SURRY POWER STATION UNIT NO. 1

Amendment No. 34  
License No. DPR-32

ATTACHMENT TO LICENSE AMENDMENT NO. 34

SAFETY EVALUATION BY THE OFFICE OF NUCLEAR REACTOR REGULATION  
SUPPORTING AMENDMENTS NOS. 34 AND 33 TO FACILITY OPERATING LICENSES NOS. DPR-32 AND DPR-37

**VIRGINIA ELECTRIC AND POWER COMPANY  
SURRY POWER STATION  
ORGANIZATION CHART**

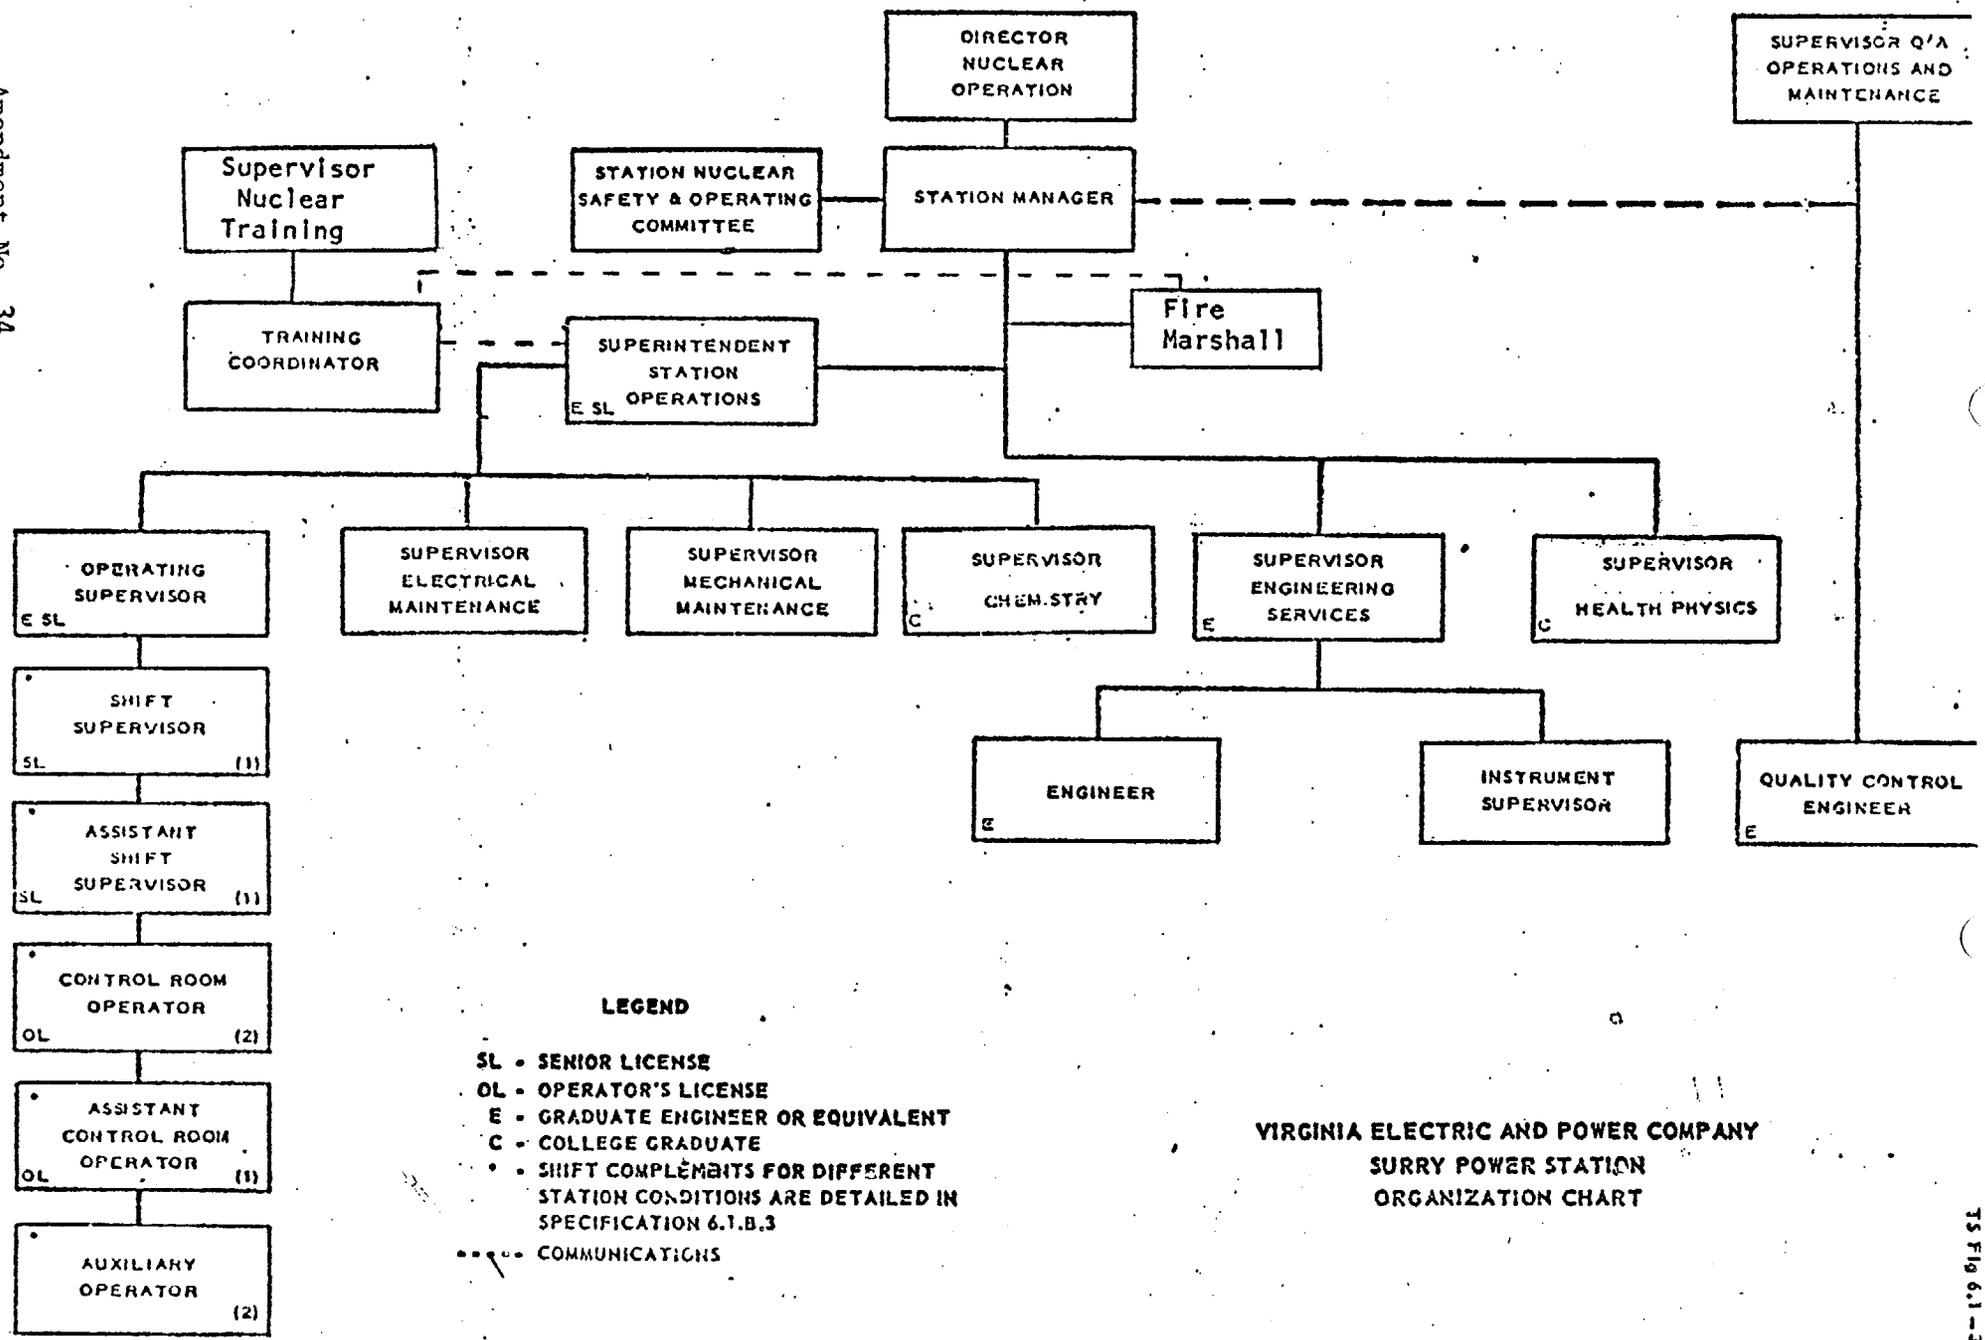
\*Responsible for Corporate Fire Protection Program
